CLIENT
ZANCOR HOMES

PROJECT LOCATION
**OLDE WINCHESTER
BROOKLIN, ONT**

DRAWING
SITE GRADING PLAN

LOT NUMBER
11

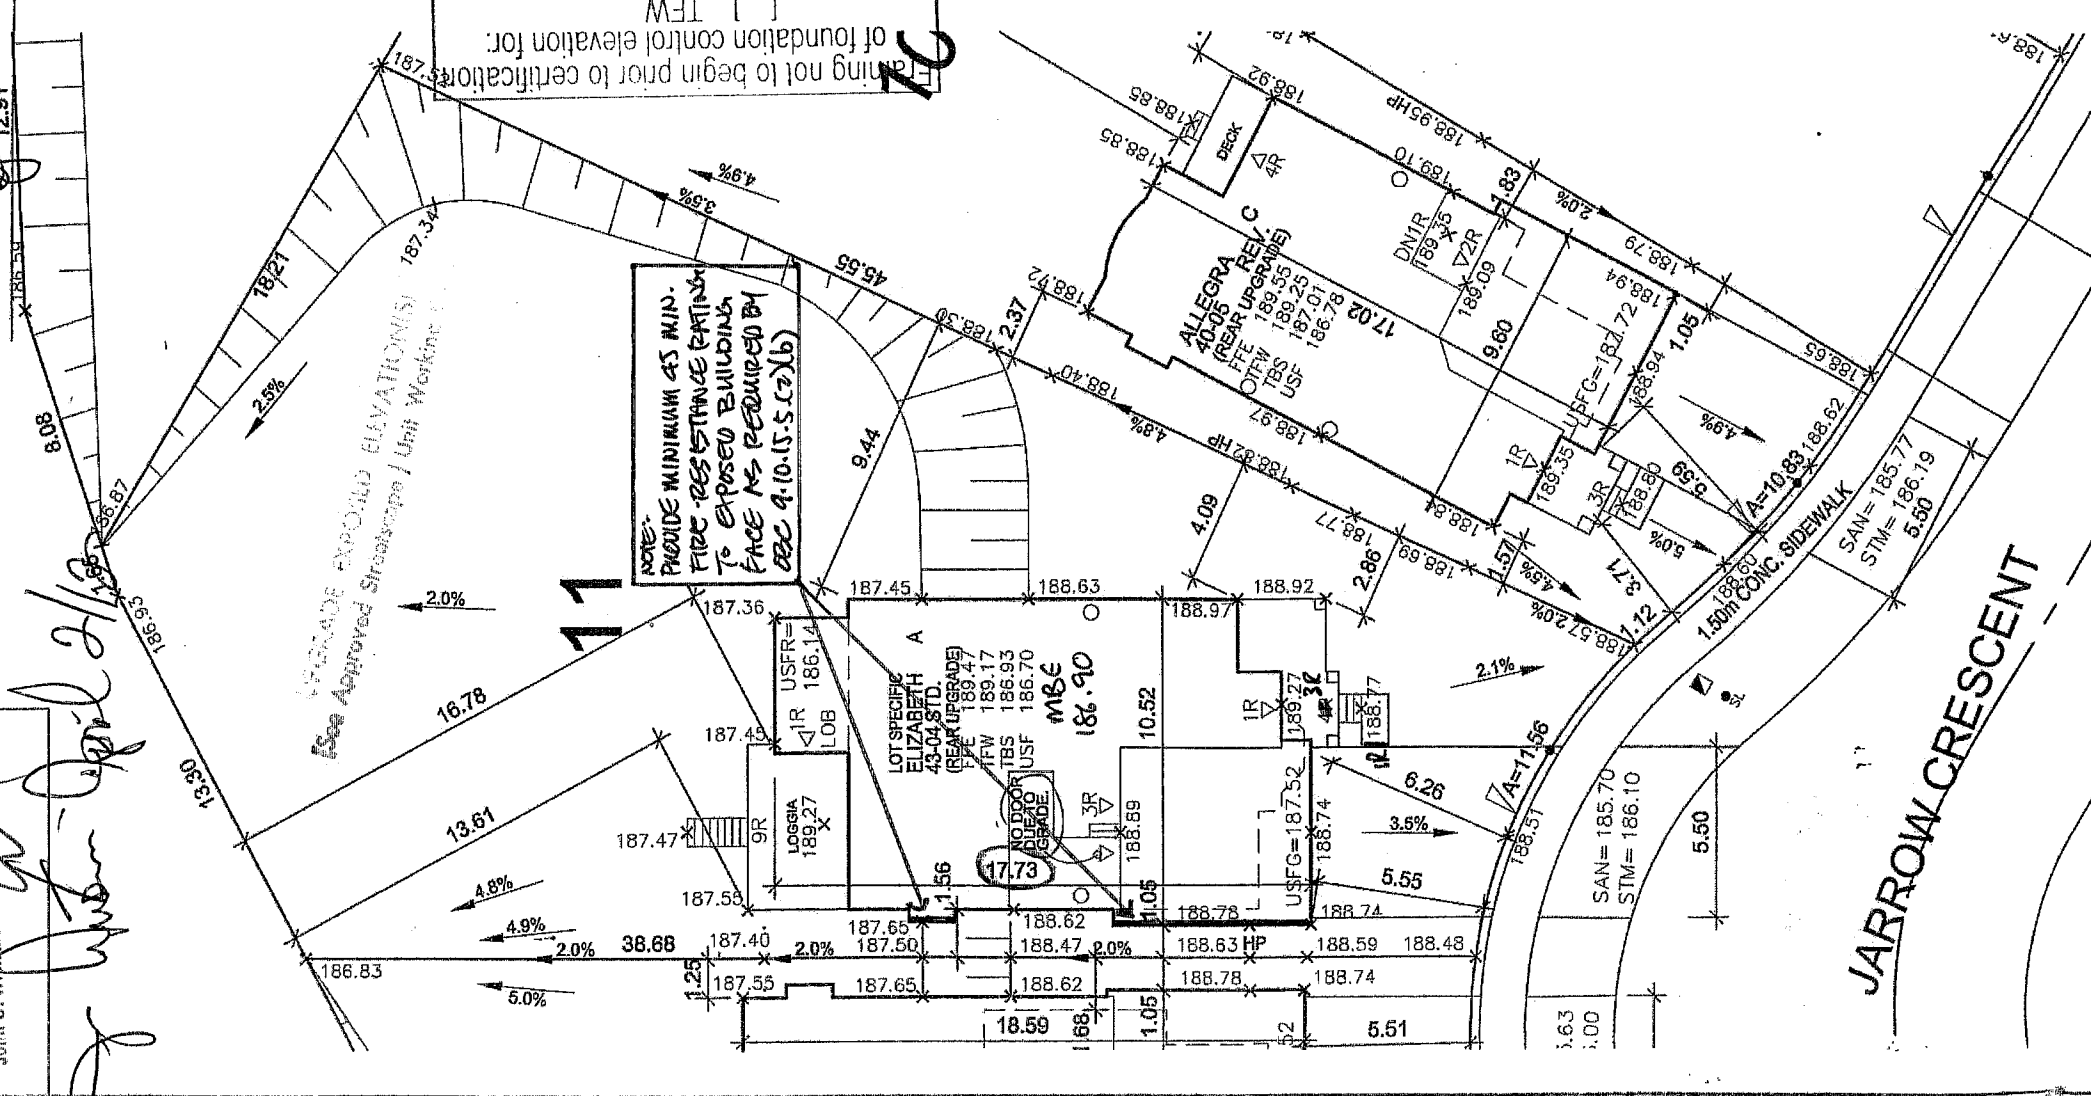
LOT GRADING PLANS APPROVED
SUBJECT TO REVISIONS NOTED
